# County of Fairfax, Virginia

## **STAFF REPORT**

**FDP 2011-PR-011-3**

To obtain Final Development Plan (FDP) approval of a 13-story office building with retail at the ground level.

Figure 9 Ultimate Alignment of Colshire Drive (Source: FDP)

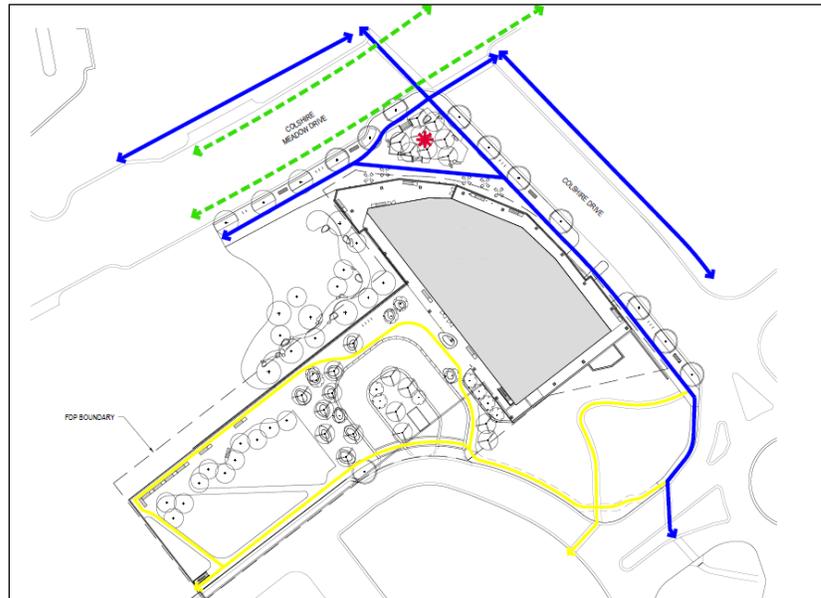
As noted earlier, the straightening and realignment of Colshire Drive is not triggered by this building in the approved proffers. Therefore, as discussed above, the treatment at the corner of the sidewalk and park area is considered interim. However, the straightening of Colshire Drive is triggered by another pending FDP application, FDP 2011-PR-011-04 (also known as

the Johnson II block), and therefore the applicant has shown the straightening and realignment of Colshire Drive on this application for informational purposes.
